FACPAC Contract Change Order

Tier 1 Project: Estill Springs Elementary Phase 2 Renovations & Addition - ESSER III
 BG Number: 22-207 District: Estill County (HB678)
 Status: Active Phase: Project Initiation (View Checklist)

CHANGE ORDER NUMBER: 03-02
 INITIATION DATE: 3/27/2023

PR # 11 Underslab Sewer Repairs @ Restroom

DUPLEX PANEL
(FIELD INSTALLED)

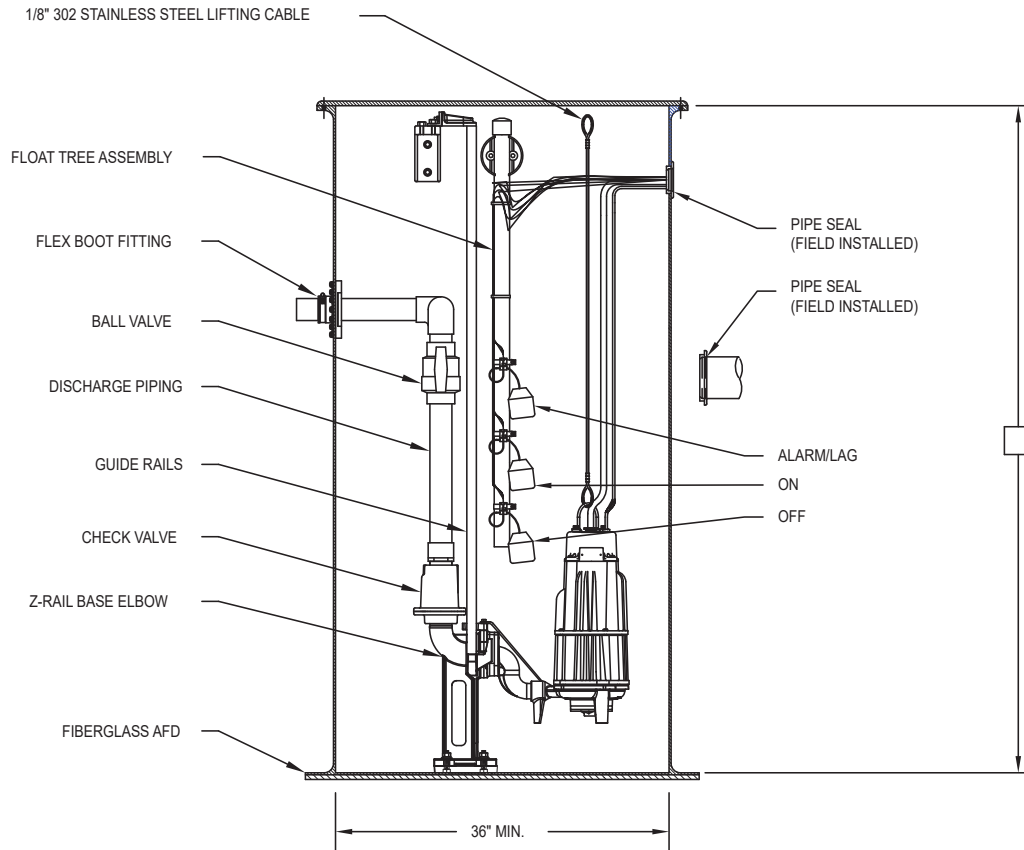
2. Provide pricing to provide and install duplex grinder pump with exterior basin and control panel installed outside the building in the sanitary line downstream of the connection of the two new classrooms. See attached selection: Zoeller Shark Series – Pump Model 840 with 45 GPM at 10' of head. Duplex control panel with NEMA 4X enclosure, audible and visual high water alarms, starting, control, and alarm circuits, circuit breaker and rated motor contactor, alternating circuit, high water alarm light with flasher, HOA switches and pilot lights. 36"W x 60"D Fiberglass outdoor basin with anti-flotation ring, rail disconnect system, inlet and discharge pipe seals, float tree with floats. Route electrical circuit from existing panel in kitchen – field verify panel location and circuit space. Pipe discharge under existing restroom to main in corridor separate from line serving the restroom fixtures. (See attached)
